Access Compliance Report Public Rights-of-Way (Curb Ramps)

Main Street: AVENIDA LA PATA Cross Street: N/A Location: E

ADA ID: RPRK211201122536 Ramp Type: Type 1 - Perpendicular Diagonal Initial Pass/Fail: Fail Overall Compliance: No Severity Score: 2

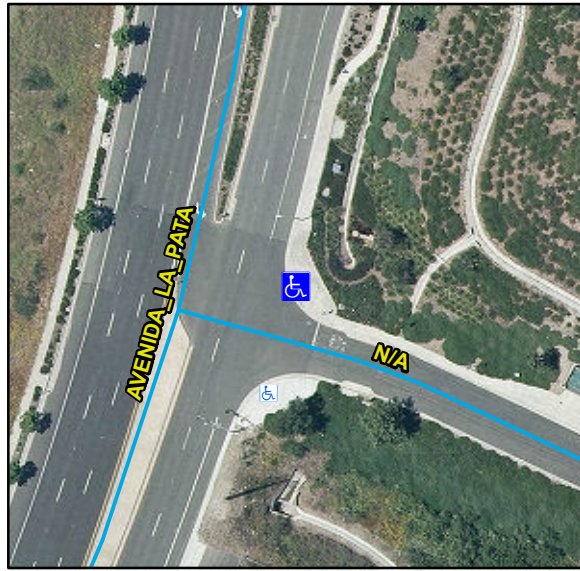
Surveyor Notes:

N/A

OC Std/PROW:

R304.2.2, R304.5.3, STD 1115

Possible Solutions:

Remove & Replace Curb Ramp With Two New Directional Ramps or Equivalent.
